Project: WBS 42833.1.1 (B-5231)
 Bridge #162 on SR 1121 over Price Creek
 Yancey County

Subject: **MINUTES OF MEETING**

| PURPOSE/DESCRIPTION: | | Pre-Bid Meeting |

From: Wafa, Zaki H
Sent: Thursday, January 21, 2010 3:39 PM
To: 'appletuck@att.net'; 'darrell@carolinasiteworksinc.com';
'jimmysturgill@stimail.com'; 'dlrowe@triad.rr.com';
'tcbuilder@aol.com'; 'timw@waynebros.com';
'richard@carolinabridgeinc.com'; 'Bruce Horldt'; 'Kevin Burns';
'kgbryantindustries@yahoo.com'; 'Ron Grigsby'
Cc: Summers, Michael K; 'Jim Mondolfi'
Subject: Yancey 162 (B-5231) Addendum to the Minutes of Pre-Bid
Conference

STATE OF NORTH CAROLINA
DEPARTMENT OF TRANSPORTATION
RALPHIGH
CAST - IN - PLACE
END BENT NO. 1
60' SPAN WITH APPROACH SLAB
27' CLEAR ROADWAY - 60° SKEW

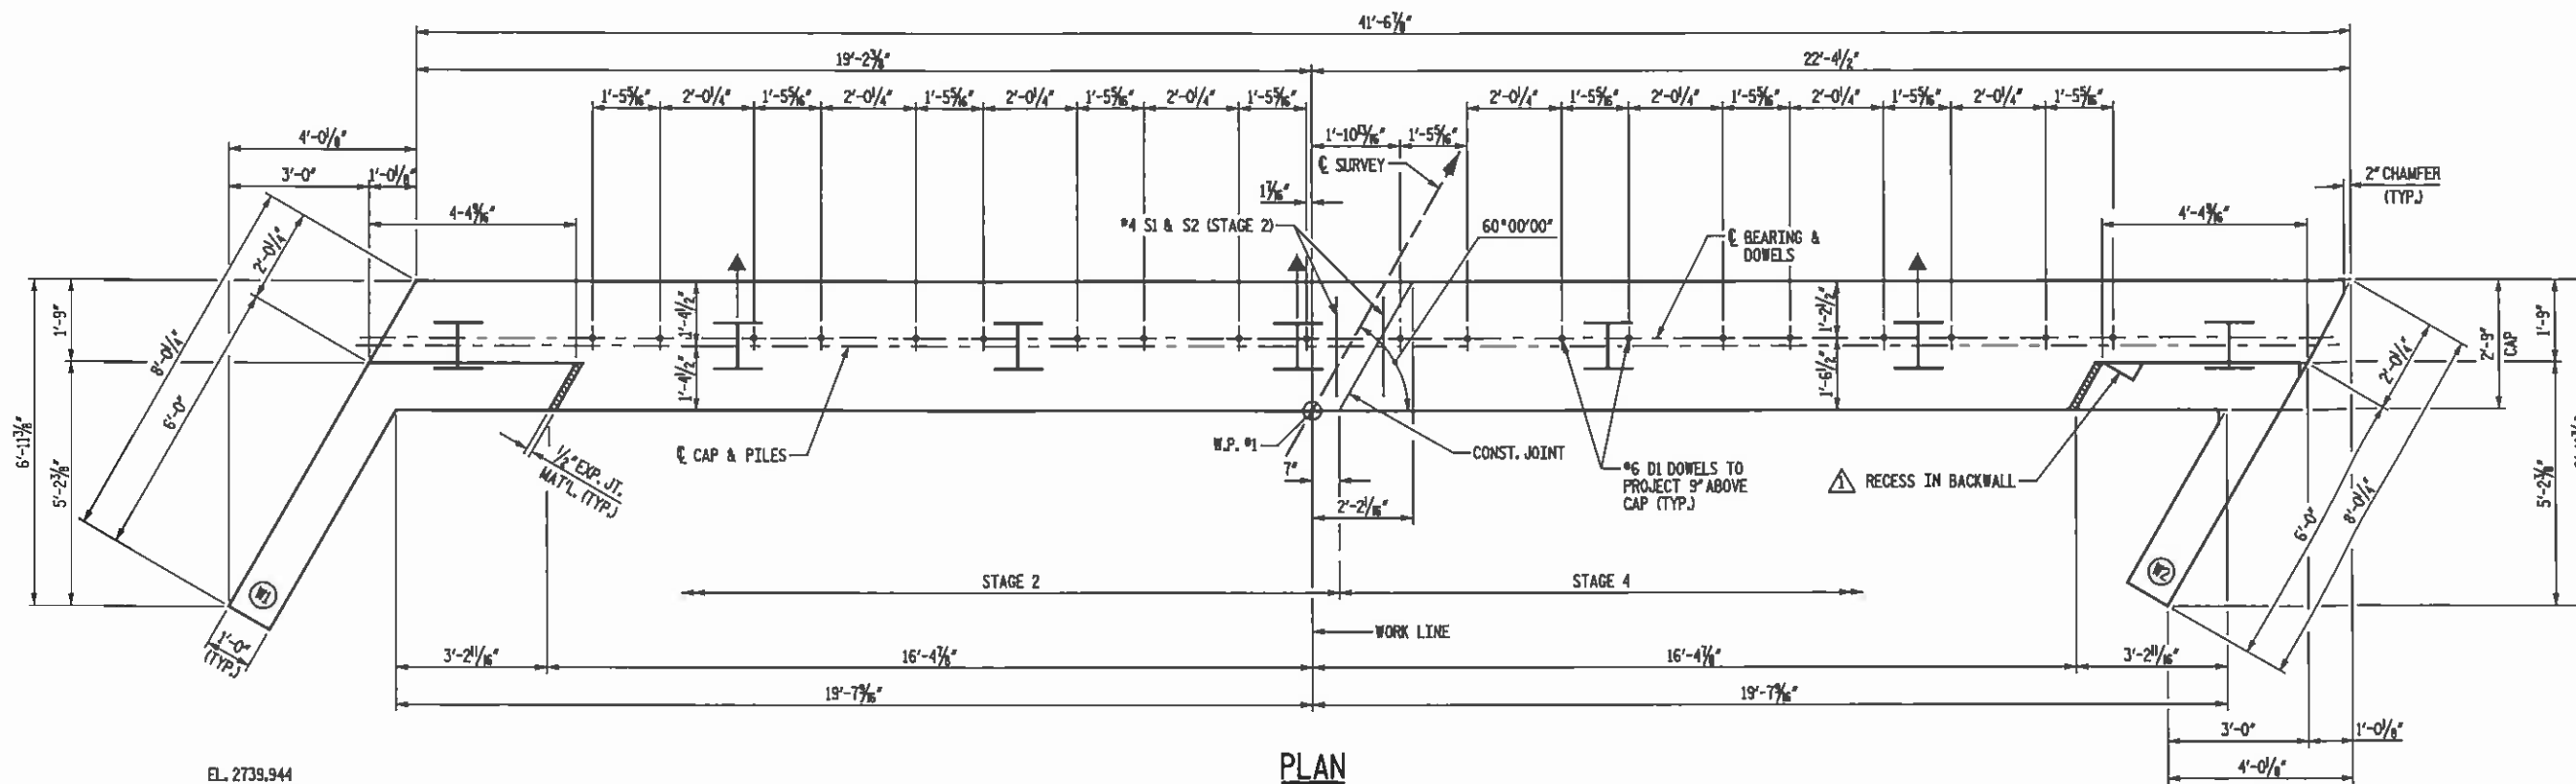
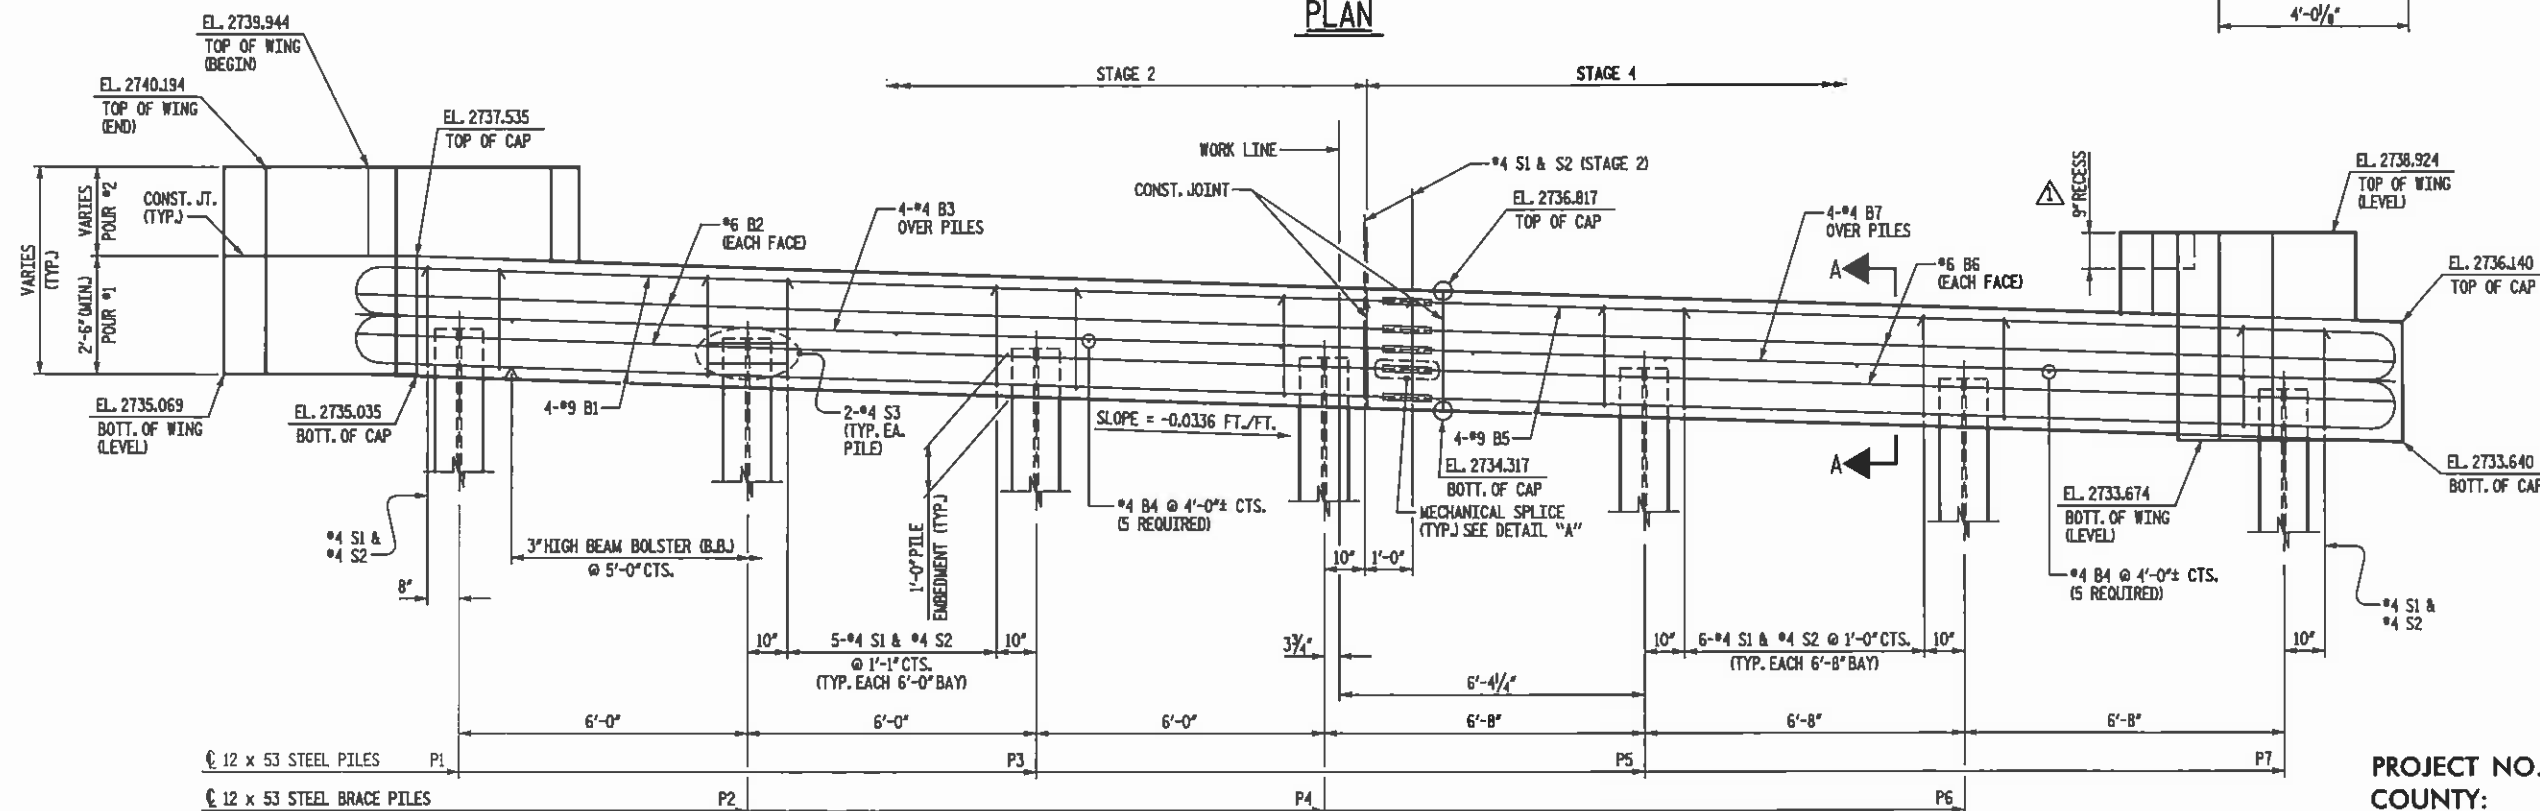
ADDED RECESS IN BACKWALL
REMOVED SECOND NOTE

STIRRUPS IN CAP MAY BE SHIFTED SLIGHTLY AS NECESSARY TO CLEAR DOWELS.

STATE OF NORTH CAROLINA
DEPARTMENT OF TRANSPORTATION
RALEIGH
CAST - IN - PLACE
END BENT NO. 2
60' SPAN WITH APPROACH SLAB
27' CLEAR ROADWAY - 60° SKEW

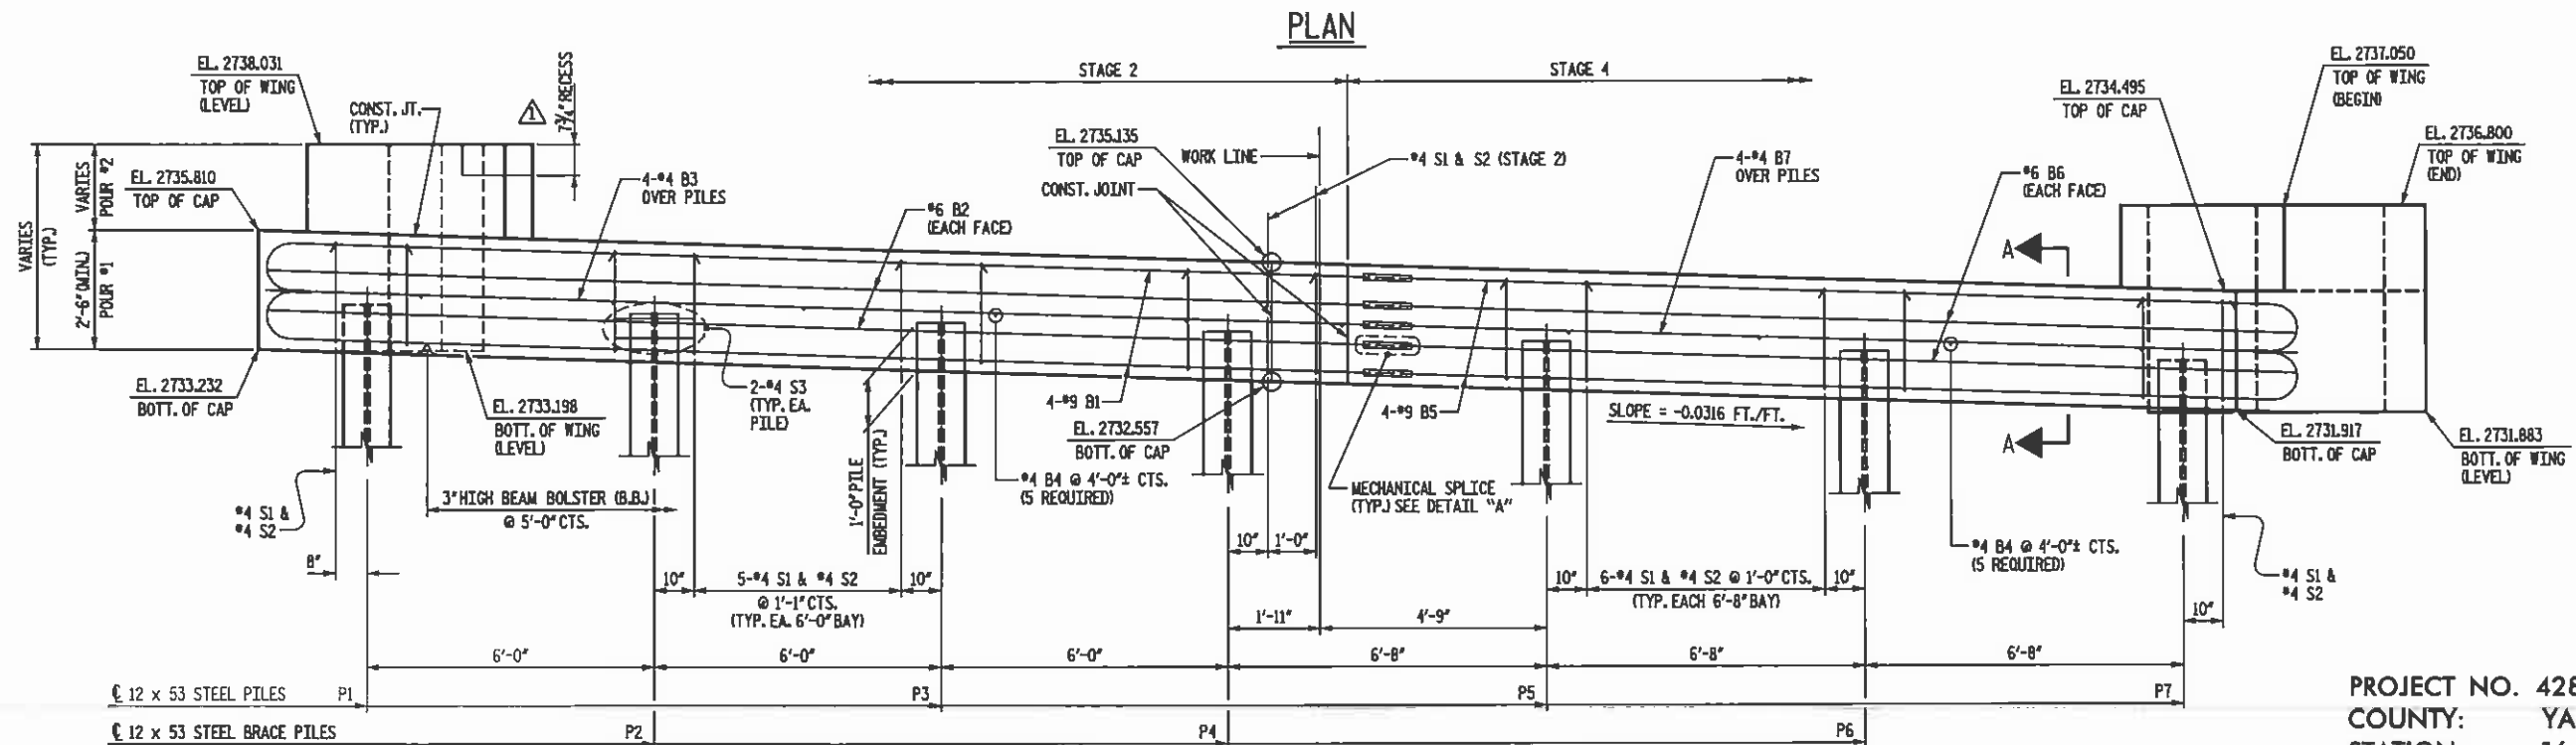
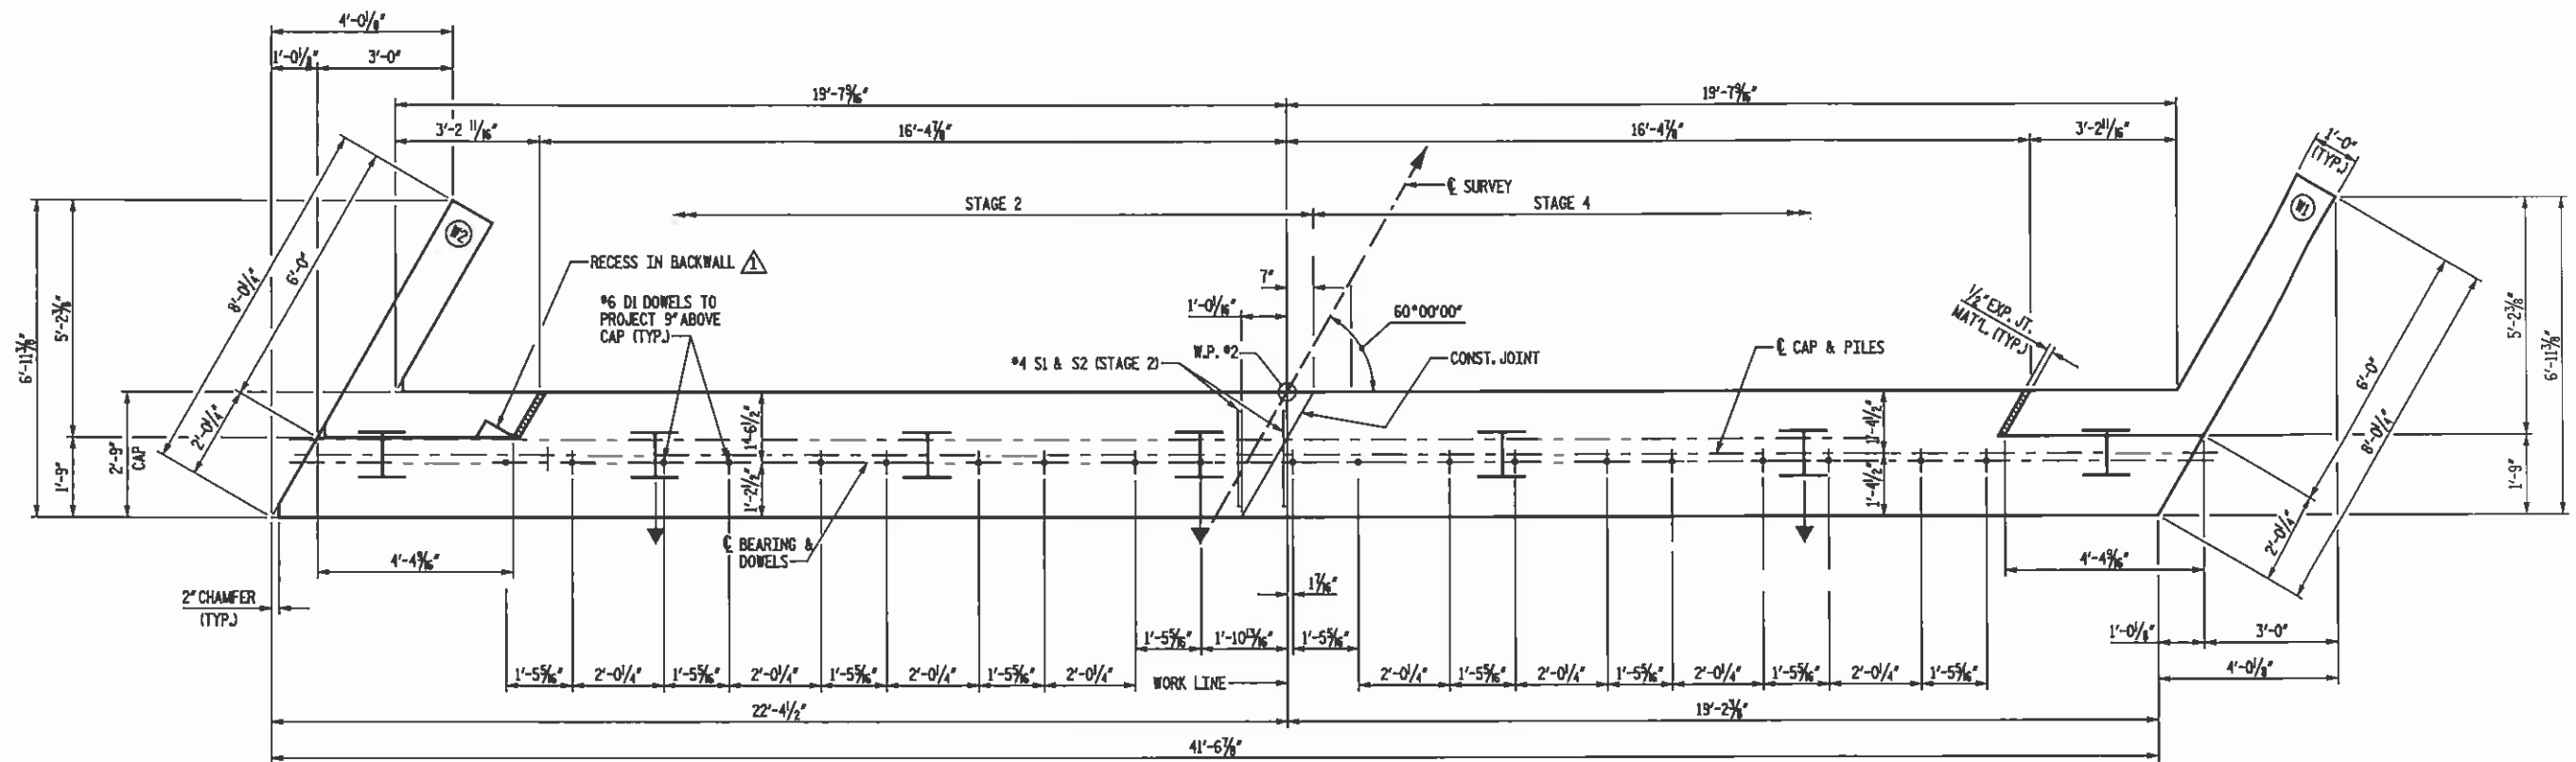
△ ADDED RECESS IN BACKWALL
REMOVED SECOND NOTE

NOTES:
STIRRUPS IN CAP MAY BE SHIFTED SLIGHTLY AS NECESSARY TO CLEAR DOWELS.

DETAIL OF RECESS IN TOP OF BACKWALL AT WING W2

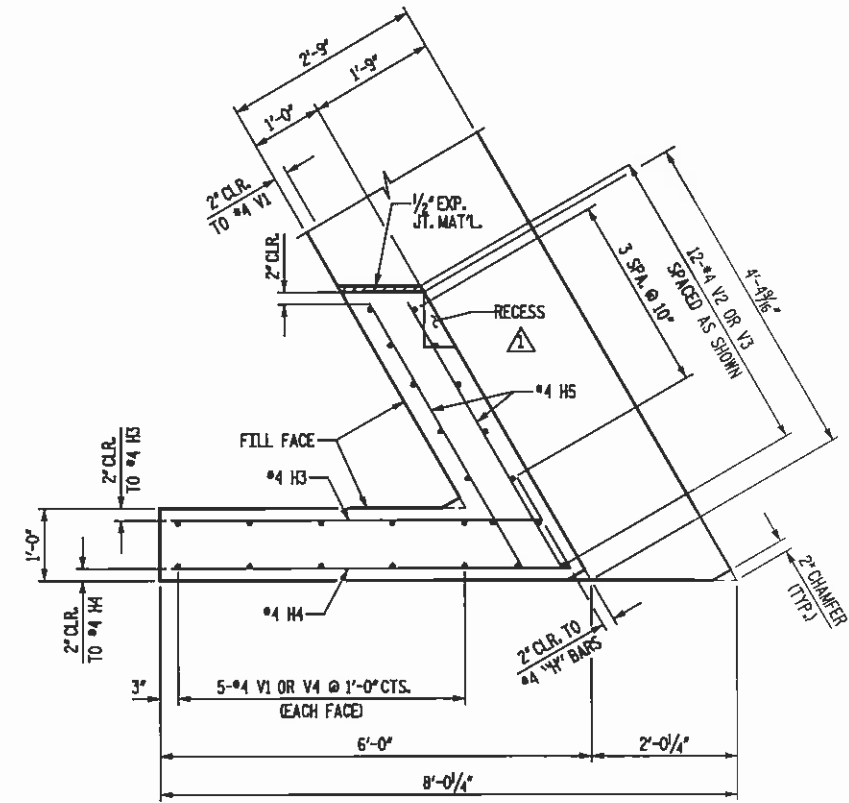
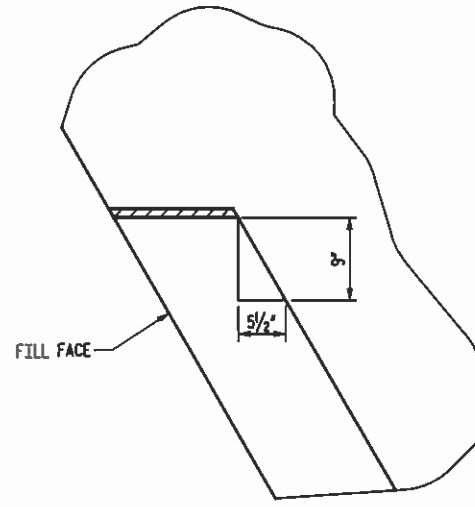
▲ ADDED RECESS DETAIL AND NOTE

NOTE:
 ▲ SHIFT, FIELD BEND OR CUT REINFORCING STEEL AS NECESSARY TO CLEAR RECESS IN TOP OF BACKWALL.

APPROACH SLAB
 27'-0" CLEAR ROADWAY
 60° SKEW

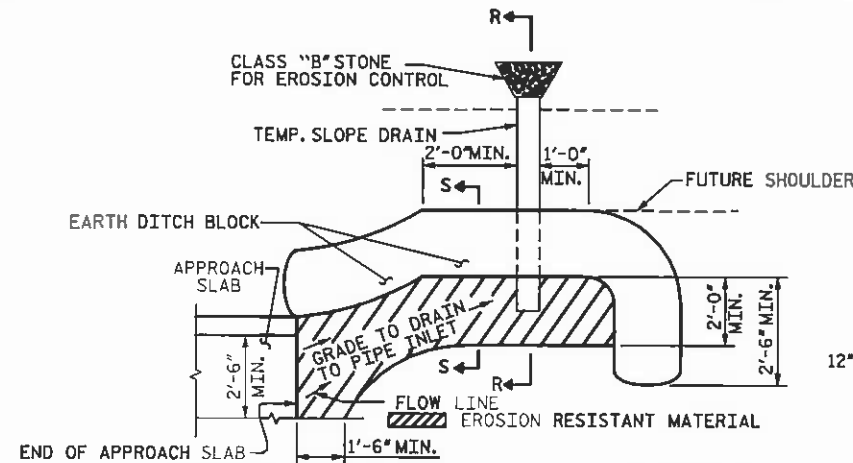
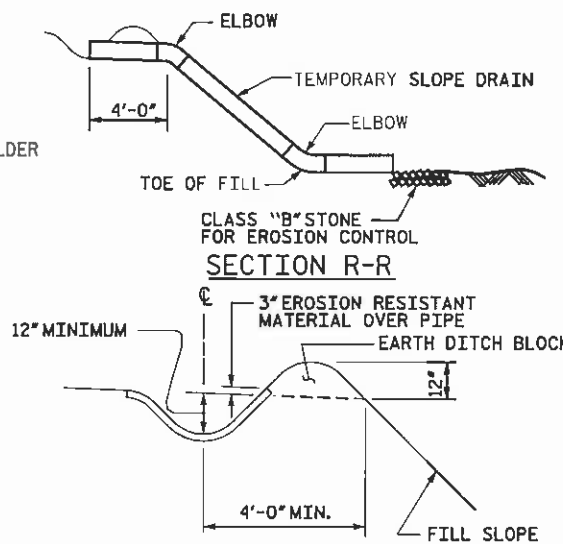
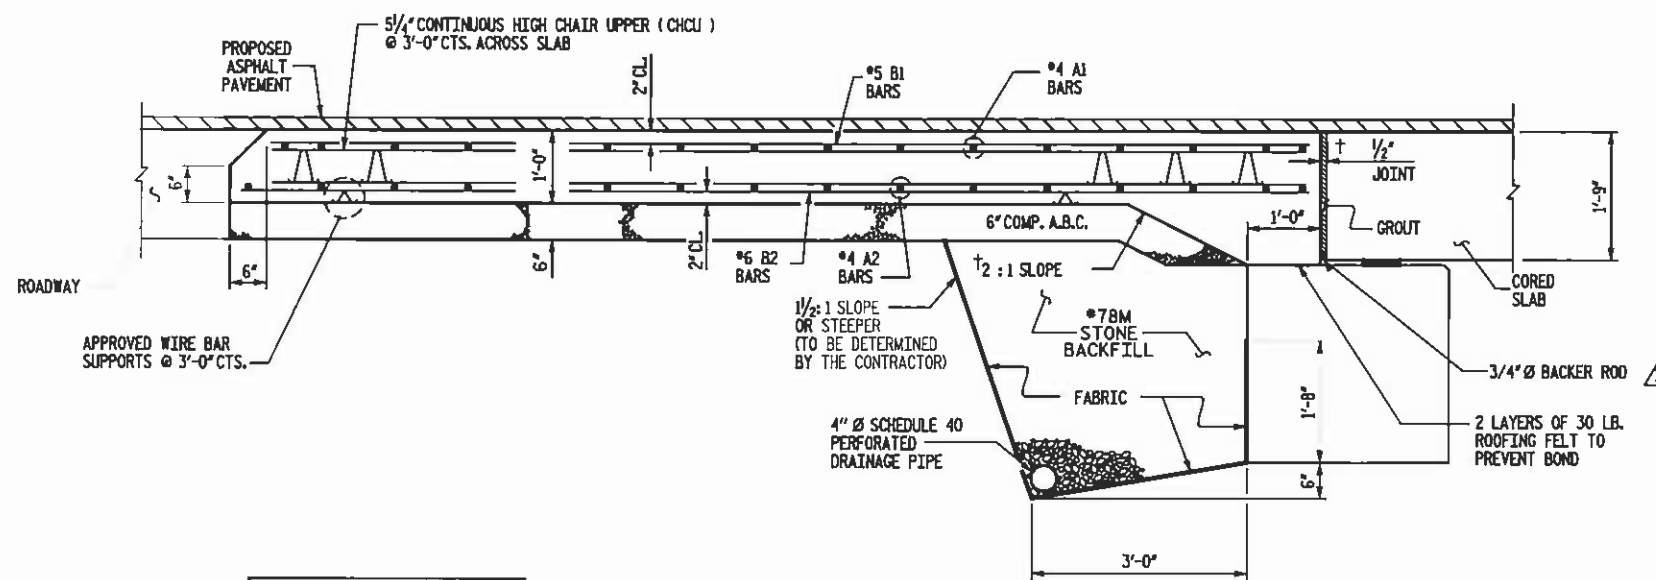
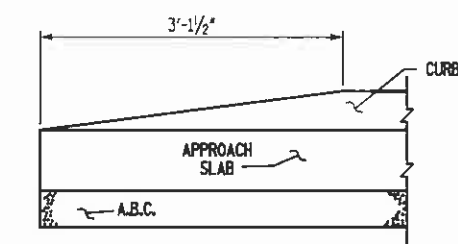
- REVISED NOTES
- ADDED BACKER ROD NOTE
- REVISED TITLE BLOCK
